**ZONING AMENDMENT,**  
**PLANNED UNIT DEVELOPMENT &**  
**SUBDIVISION STAFF REPORT**

**Date: October 5, 2006**

| <b><u>SUBDIVISION NAME</u></b>                  | Paul Persons Subdivision, Resubdivision of Lot 1  |
| <b><u>LOCATION</u></b>                          | 4474 Halls Mill Road<br>(North side of Halls Mill Road, 4/10 mile± West of the<br>North terminus of Riviere du Chien Road)  |

# SITE PLAN

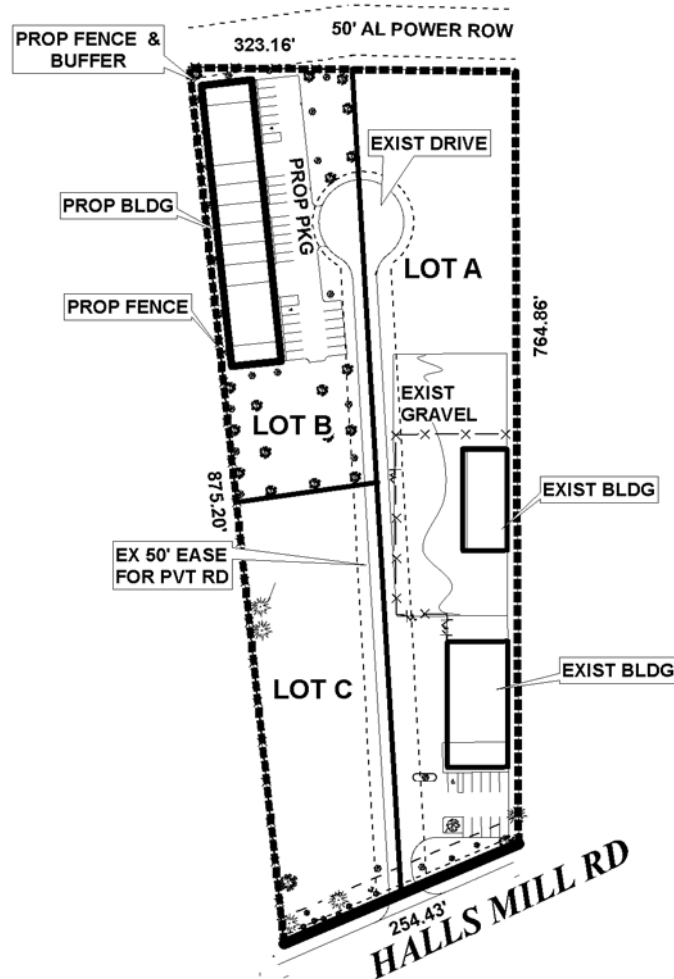
The applicant has revised the Subdivision application to propose three lots instead of two lots. Proposed Lots A and C will have frontage onto Halls Mill Road, while proposed Lot B will have no frontage on a public street. Section V.D.4. of the Subdivision Regulations states that *“except for lots on private streets as allowed by Section VIII., every lot shall abut a dedicated and maintained public street.”* Lots are allowed to front a private street when that street is built to the minimum standards contained within Section VIII.E.2.c. of the Subdivision Regulations. Additionally, no documentation was submitted regarding the construction standards of the

private street, which appears to also have been constructed without permits. The site plan and plat do not comply with the private street standards.

The three proposed lots will be served by an existing common driveway approximately 24-feet in width, and with one curb-cut onto Halls Mill Road. The driveway has a cul-de-sac at the terminus that is approximately 80 feet in diameter. It is not clear if the existing driveway meets minimum construction standards of the Subdivision Regulations for a private street.

The site plan shows proposed new development occurring on Lot B, with Lot C being reserved for future development. The proposed building on Lot B will be set back 10 feet from the North and West property lines, thus the reason for the rezoning application requesting a reduction in the 20-foot wide buffer condition from 1997. The site plan includes a note stating that the West boundary line would include substantial buffering with existing and new landscaping and trees, and a 6-foot high privacy fence as part of the proposed 10-foot wide residential buffer. It appears, however, that there is adequate room on the site to accommodate the proposed development on the site and the required 20-foot buffer setbacks.
